35/15-03N **REVISED** 15 West Lenox

Chevy Chase Historic District *pool + balcony*

Staff item

**Jundanian Residence**  
 15 West Lenoir Street  
 Chevy Chase, MD

Title Reforestation Plan

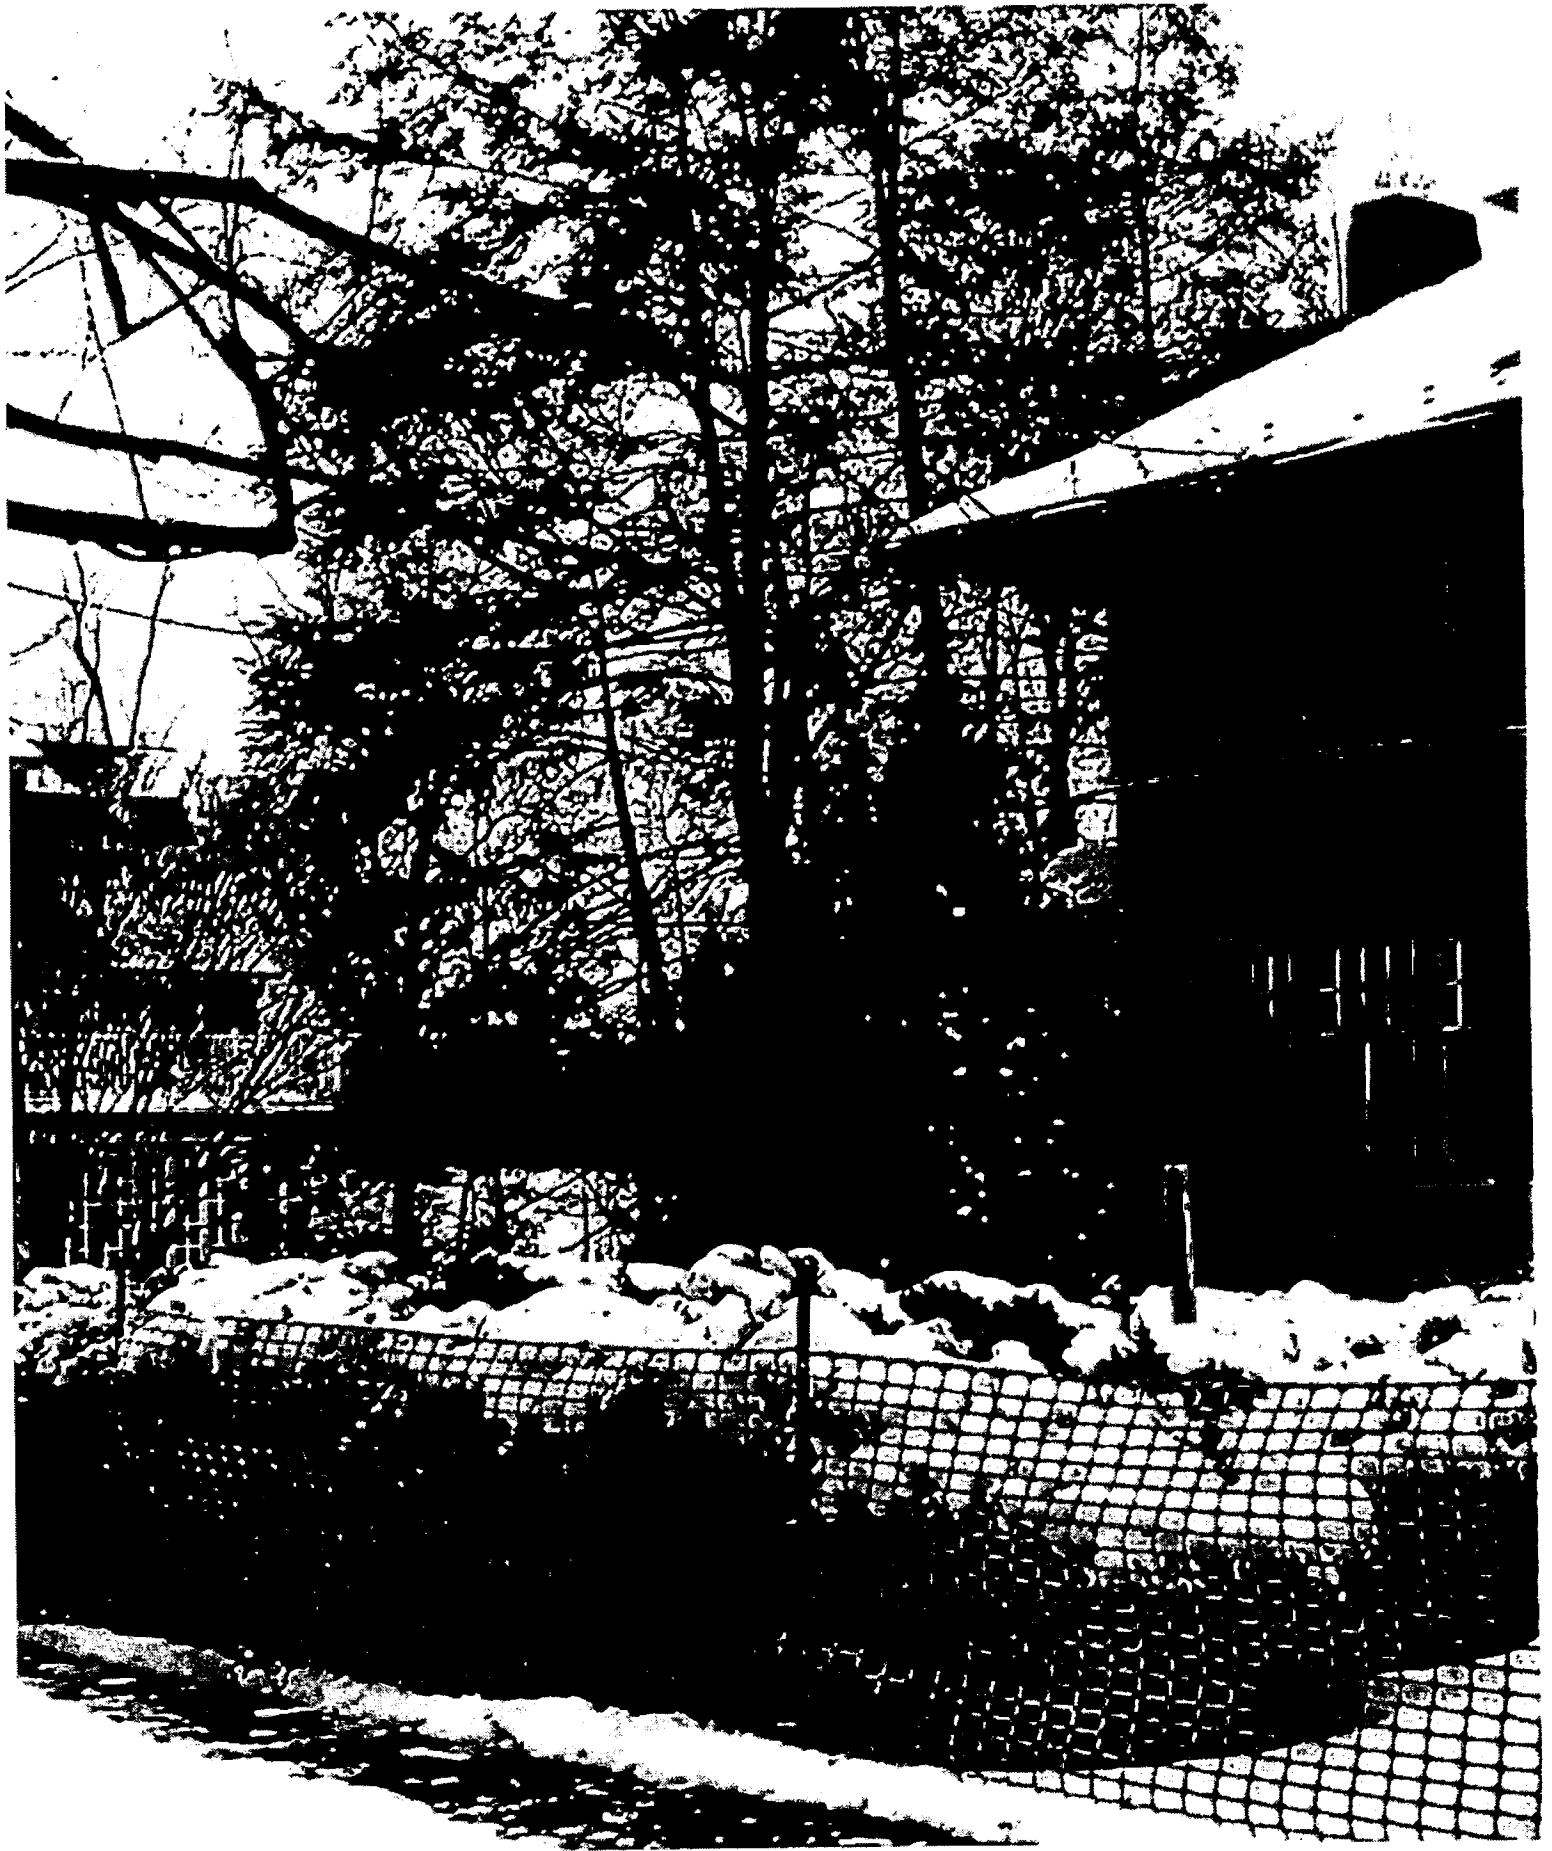
The applicants are proposing removal of 5 hemlock trees located on the left (west) side of the house. The hemlocks are 17", 15", 11", 10", and 8" in diameter. See site plan with proposed tree removal in Circle \_\_\_\_\_ and photos of the hemlocks in Circles \_\_\_\_\_.

japonica), one Japanese Maple, and an additional large canopy tree to be placed somewhere on the property. The evergreens will be 10-12 feet tall at the time of planting and will grow at a rate of 2-3 feet per year and will be planted along the west side property line. The Japanese Maple will be 12-14' tall and will be planted in the location of the removed hemlocks. See reforestation plan in Circle \_\_\_\_\_.

Trees in green (6 *Cryptomeria japonica* 'Yoshino' and 1 *Acer palmatum*) represent the replacement trees for the hemlocks that are proposed to be removed.

(2) the applicants must reforest with at least 6 *Cryptomeria Japonica* trees, as described in the reforestation plan submitted by the applicants for the record of this matter, and one additional deciduous hardwood tree that must be at least 3 inches in caliper at the time of installation and must be of a species that achieves a mature height of at least 45 feet; and

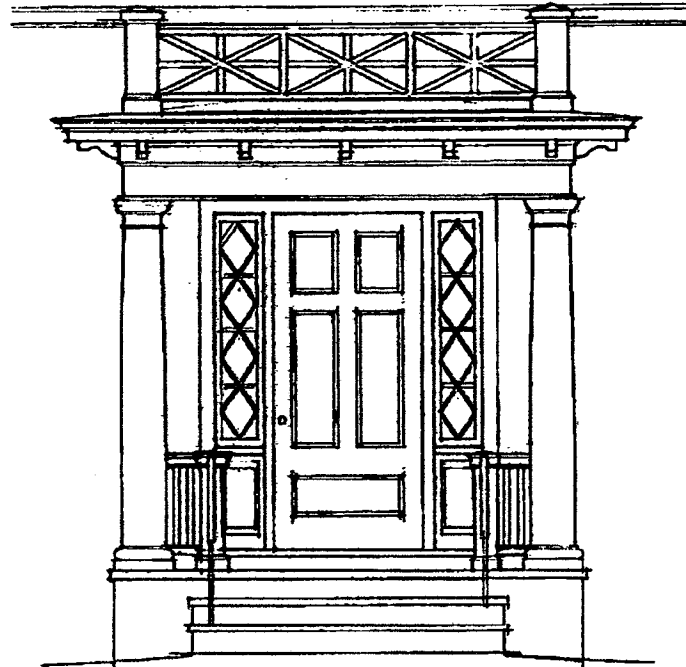
Following elevation shows the proposed front porch. The upper railing is slightly modified to simplify the design.

Project #	03027	Date	August 16, 2006	Scale	1/8" = 1'-0"
Drawn By	TS	Checked By	NW	Cad File	
Sheet #	L2.1	Title	Materials Plan	#	
		Date		Revisions

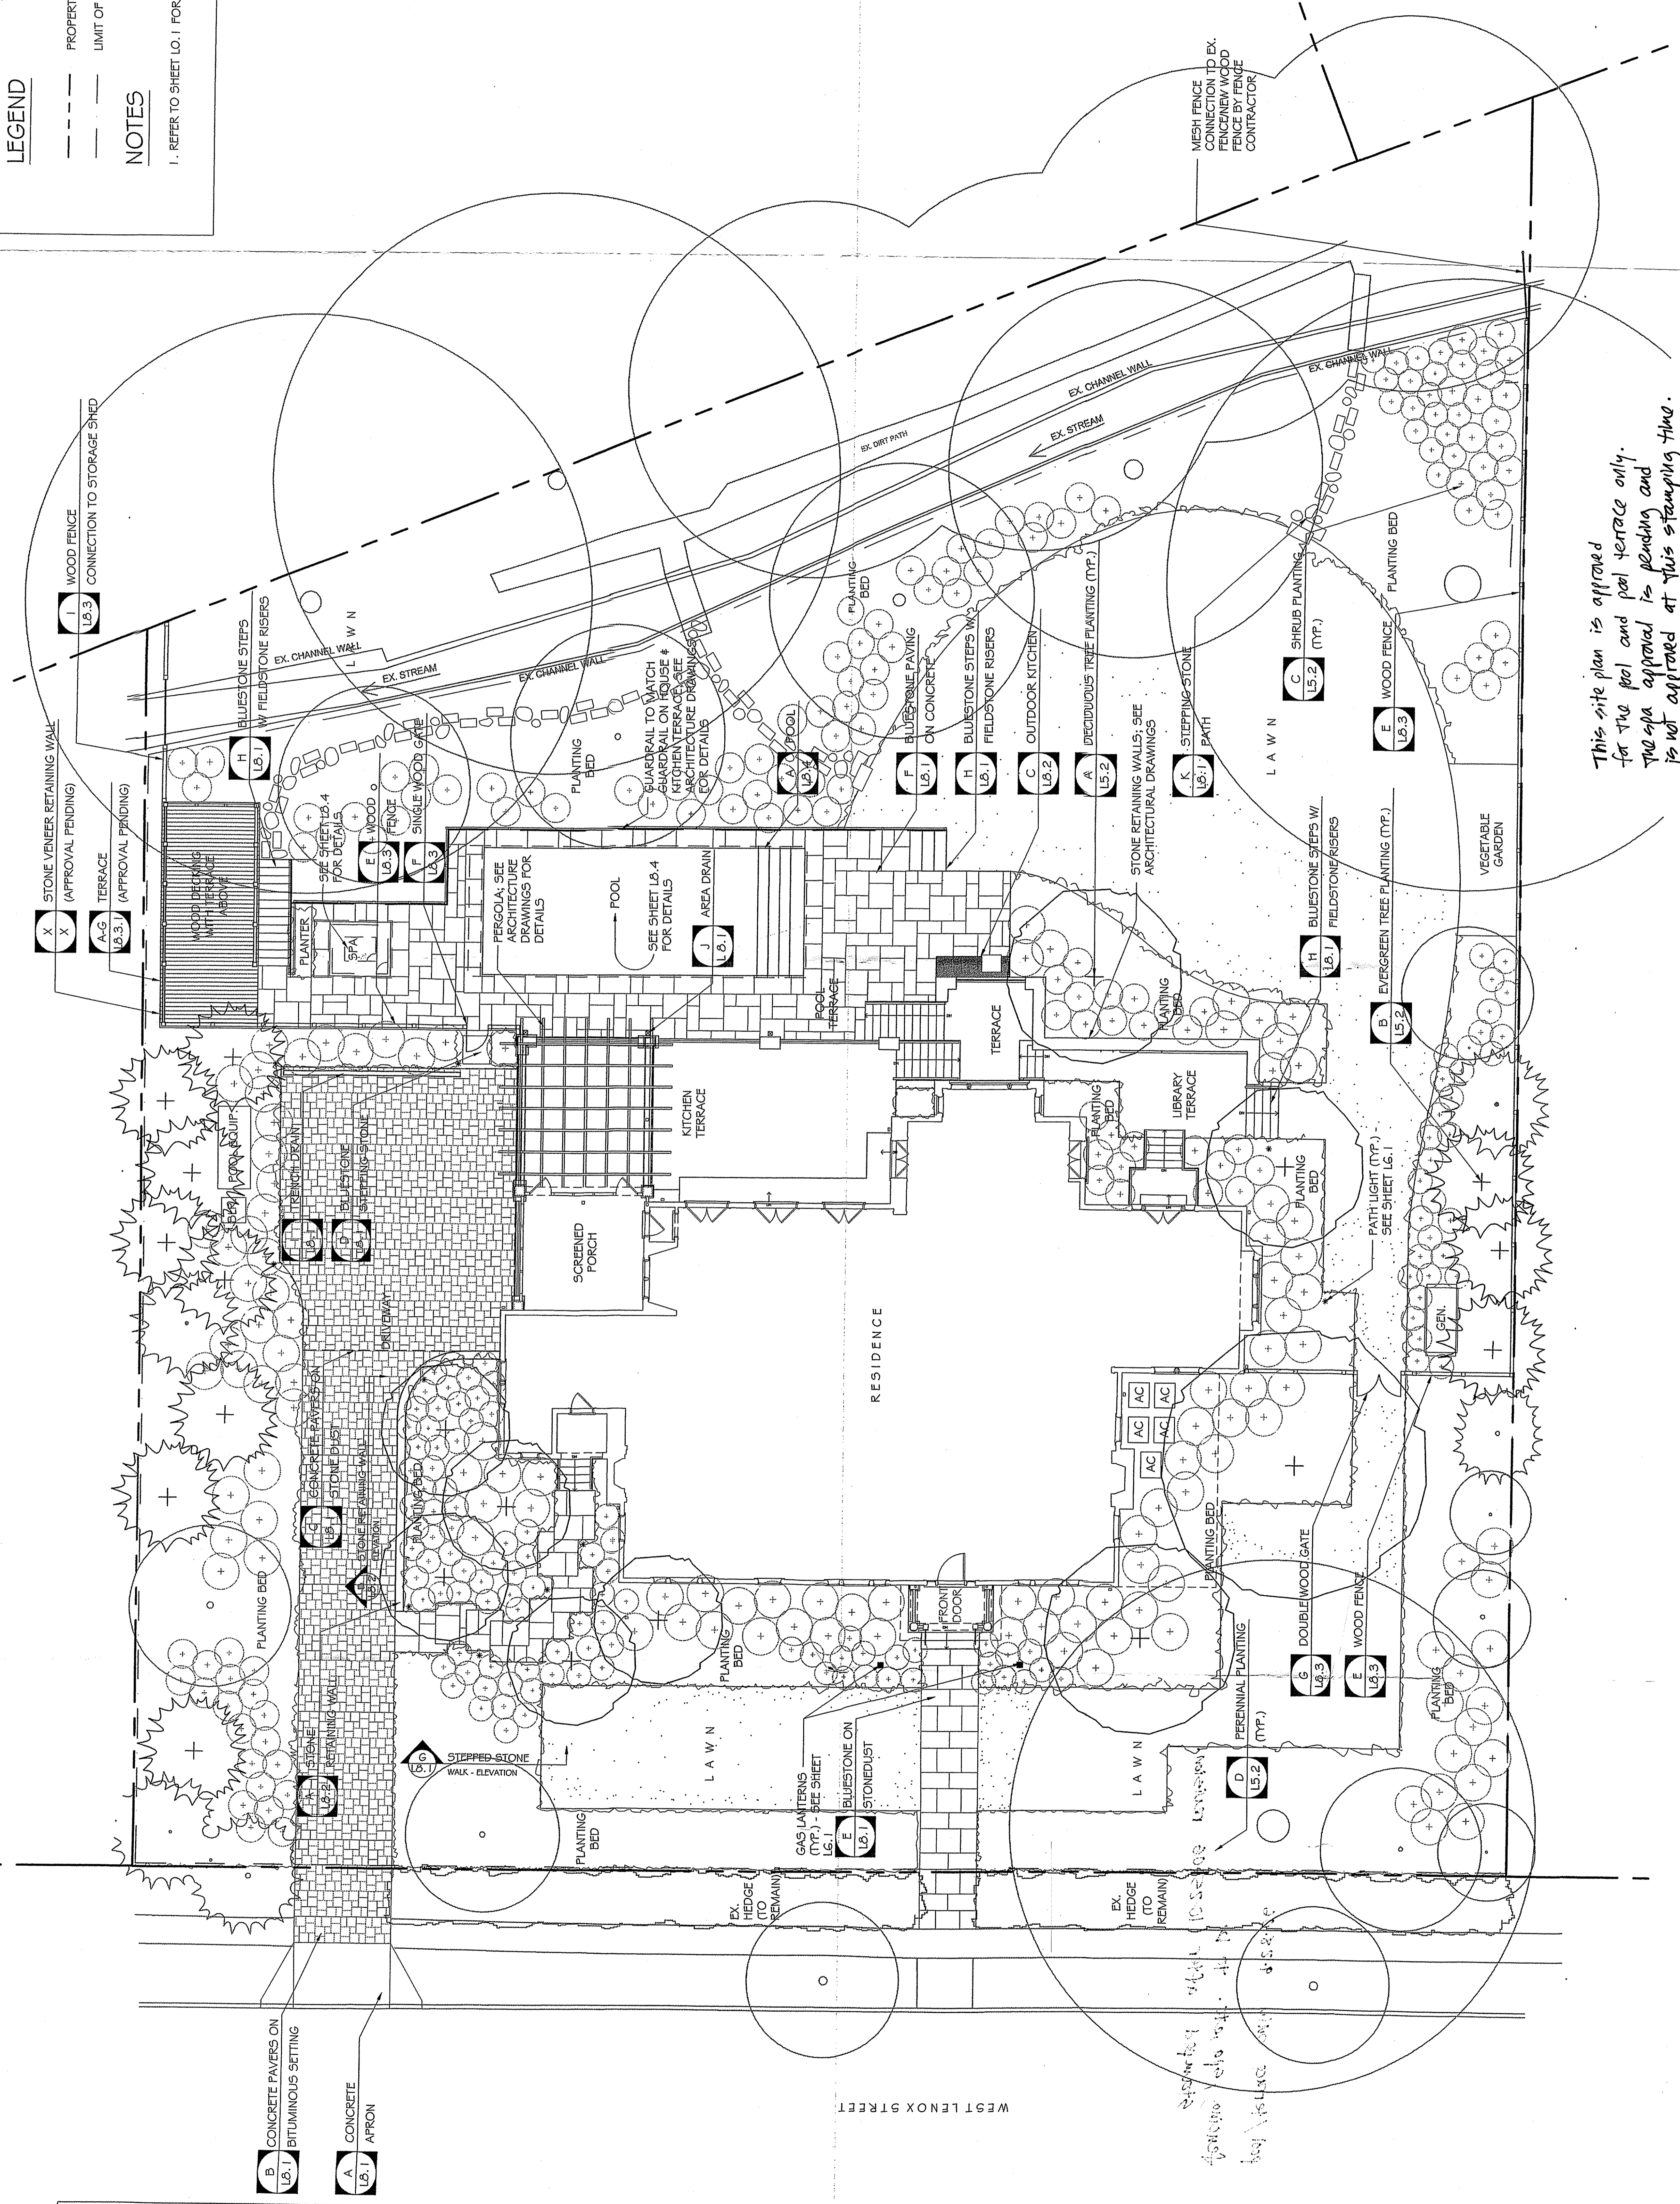
This site plan is approved for the pool and pool terrace only. The spa approval is pending and is not approved at this stamping time.
